MODEL 84, 84-F (Early Type)

MODEL 84, 84-F (Late Type)

DATA SHEET ATWATER-KENT-11

FIG. 287. DIAGRAM OF EARLY-TYPE MODEL 84 AND 84-F (A. C.-OPERATED).

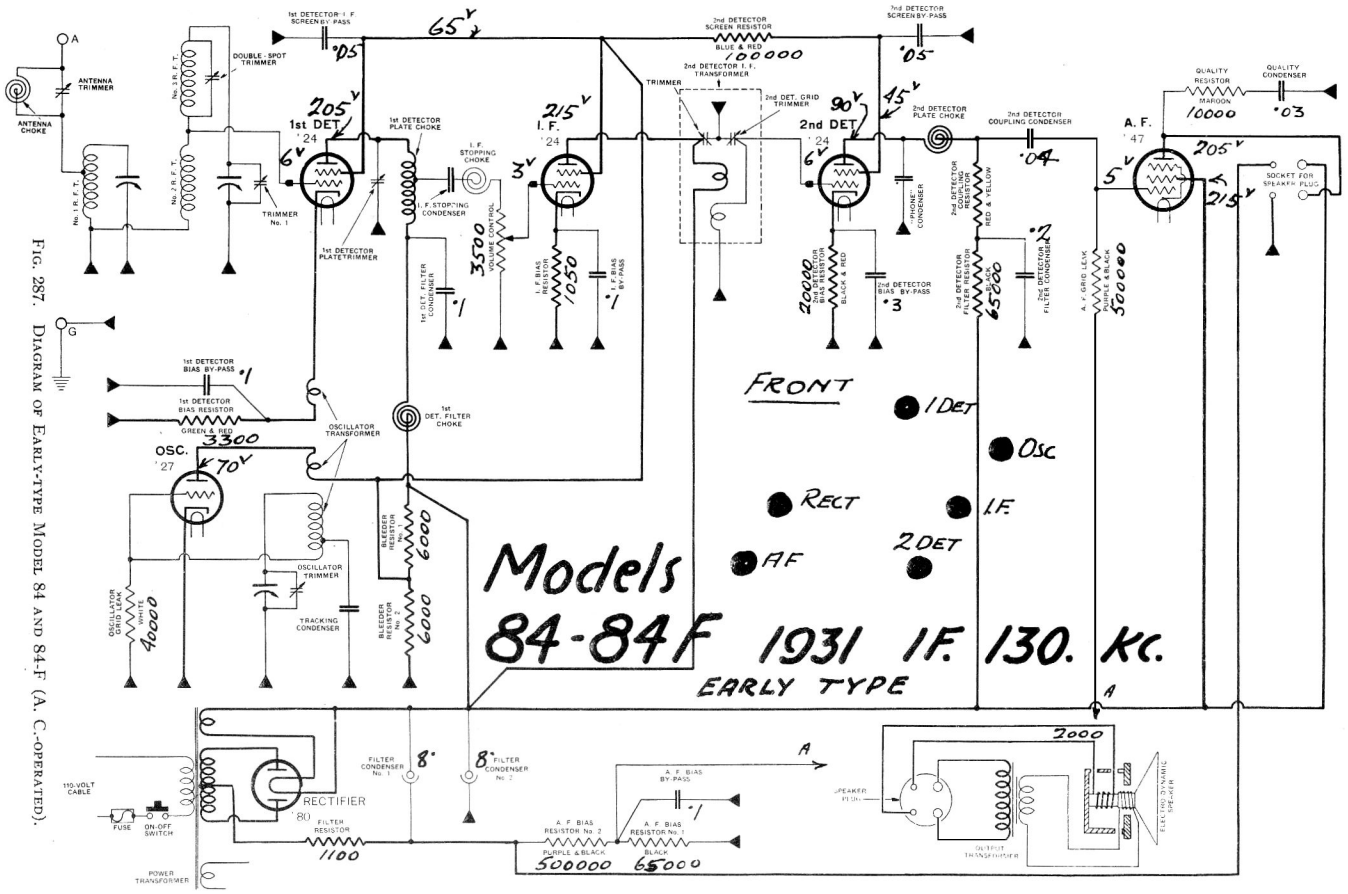
In Model 84-F, the filter resistor (connected in series with the center-tap of the high-voltage winding) is NOT used.

The filter resistor shown in the above diagram is NOT used in Model 84-F.
This set has a 1st-detector plate filter choke and condenser not shown in the diagram.
